FIRE SAFETY INSPECTION REPORT

Factory Name: Dekko Designs Ltd. (New Building)

Date: 25th August' 2016

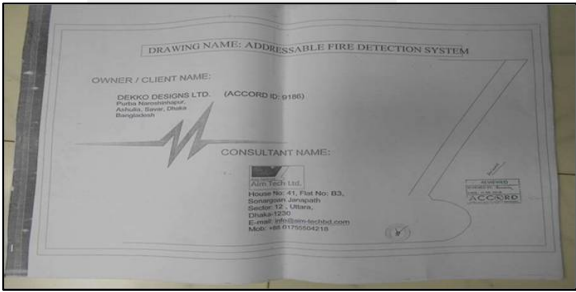
SI No.	Category	Findings	Required Action	Remediation Time Frame	Pictorial Evidence
3	Fire rated construction	Areas used for in-process storage of combustible materials are open to the surrounding occupancy. (2nd and 3rd floor, cutting section)	Provide defined storage areas and limit the storage arrangement as follows:- 1. General Condition: Maximum height of 2.4m and maximum area of 23m². Separate areas of unenclosed combustible storage by a minimum clear distance of 3m. - or 2. Enclose the storage area from the surrounding occupancy with a minimum 1 hour construction.	Within 3 months

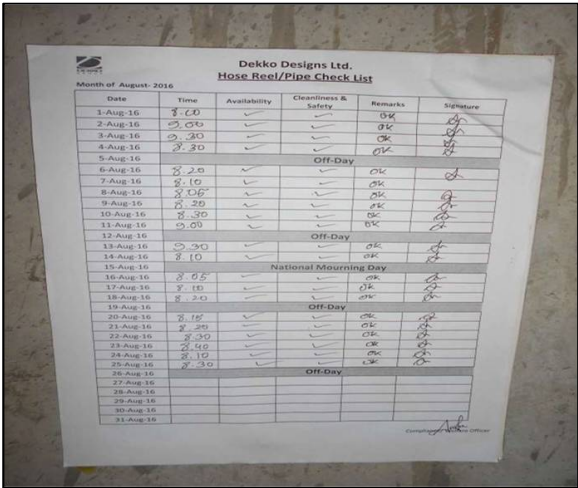
SI No.	Category	Findings	Required Action	Remediation Time Frame	Pictorial Evidence
7	Egress	Fire door has been installed in most of the exits at production and store floors. Doors were found forcibly opened for functional purpose by non-mechanical means. (All floors)	If fire doors are required to be held open for functional reasons, provide automatic-closing devices interfaced with the fire alarm system.	Within 3 months	
8	Fire Protection	Currently no Fire alarm system is operating. An addressible fire alarm system installation is on-going. Drawing for the fire alarm system has been reviewed by Accord.	Complete installation of fire alarm system as per NFPA-72.	Within 4 months
